AMENDMENTS TO THE DRAWINGS

REMARKS

FIG. 1

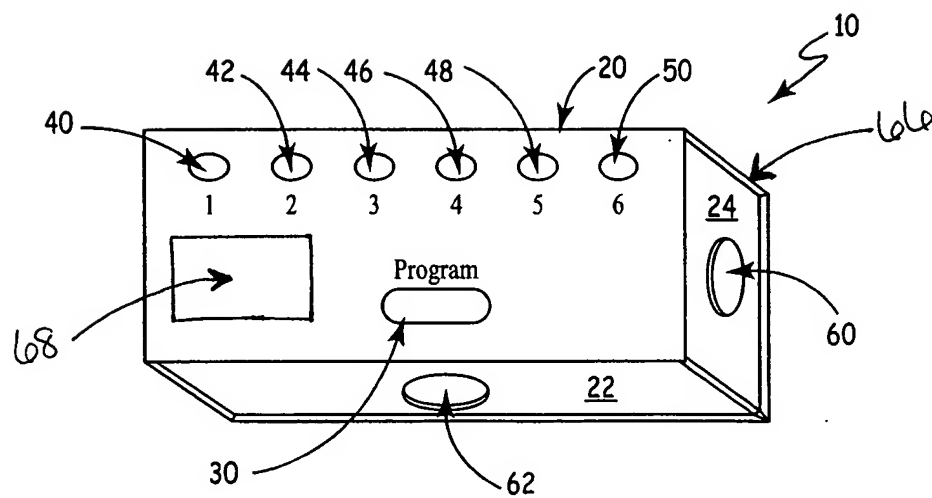
FIG. 1 has been amended to show solar panel 66 and LCD screen 68. Support for the amendments to FIG. 1 can be found throughout the specification of the application as filed, for example at page 8, line 19 – page 9, line 8. Therefore, no new matter has been added.

The drawings were objected to under 37 C.F.R. § 1.83(a). FIG. 1 has been amended to show solar panel 66 and LCD screen 68. Support for the amendments to FIG. 1 can be found throughout the specification of the application as filed, for example at page 8, line 19 – page 9, line 8. Therefore, no new matter has been added.

FIG. 3

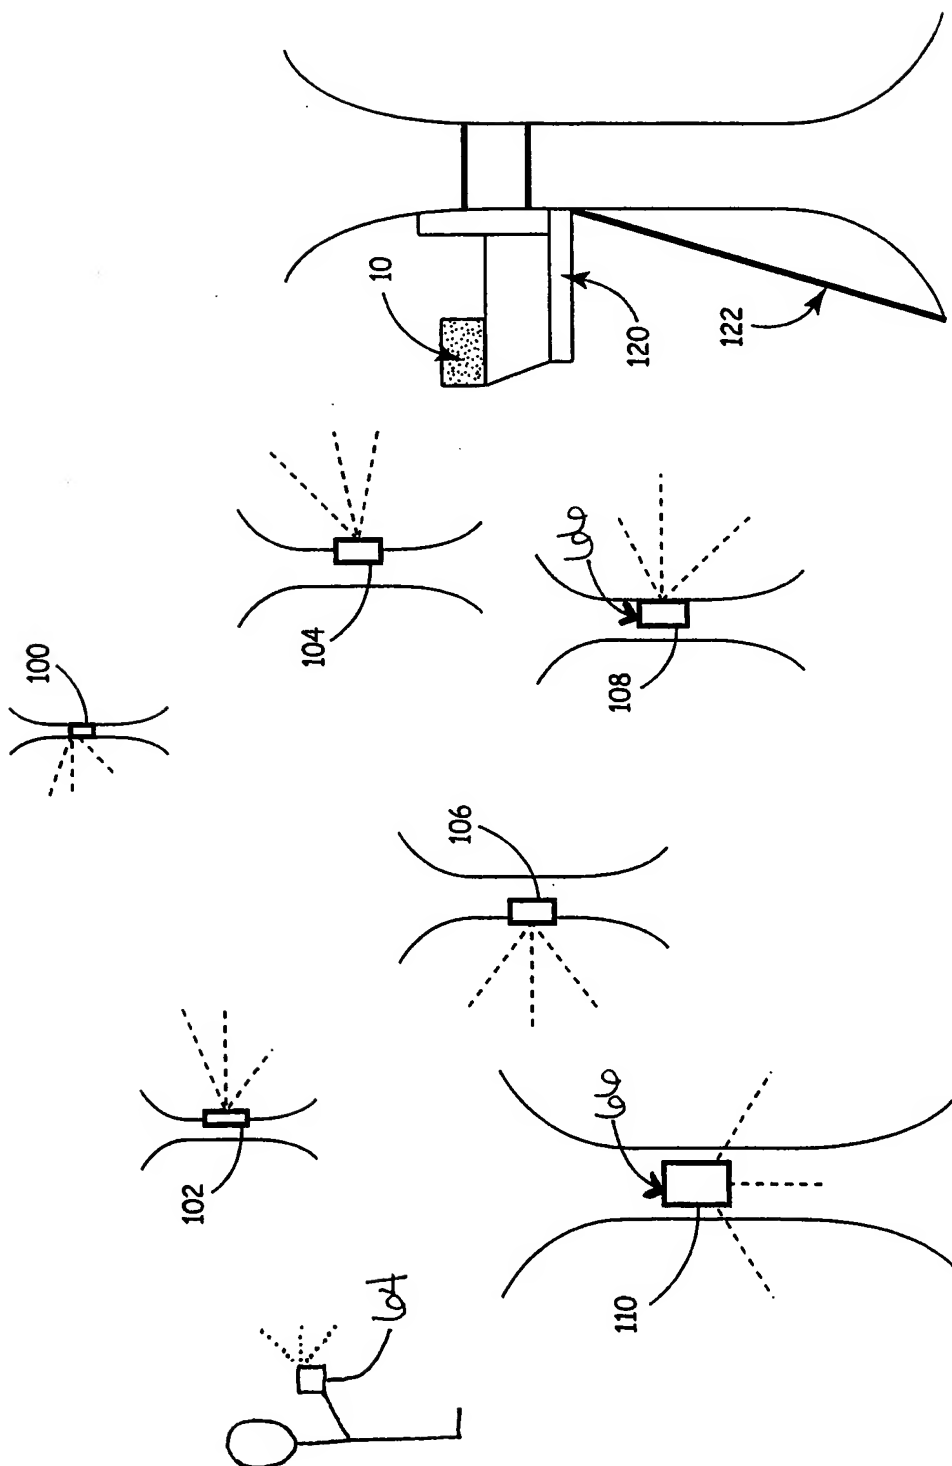
FIG. 3 has been amended to show solar panels 66 and remote signal transmitter 64. Support for the amendments to FIG. 3 can be found throughout the specification of the application as filed, for example at page 7, lines 1-12, and page 9, line 20 – page 10, line 2. Therefore, no new matter has been added.

FIG. 3 has been amended to show solar panels 66 and remote signal transmitter 64. Support for the amendments to FIG. 3 can be found throughout the specification of the application as filed, for example at page 7, lines 1-12, and page 9, line 20 – page 10, line 2. Therefore, no new matter has been added.
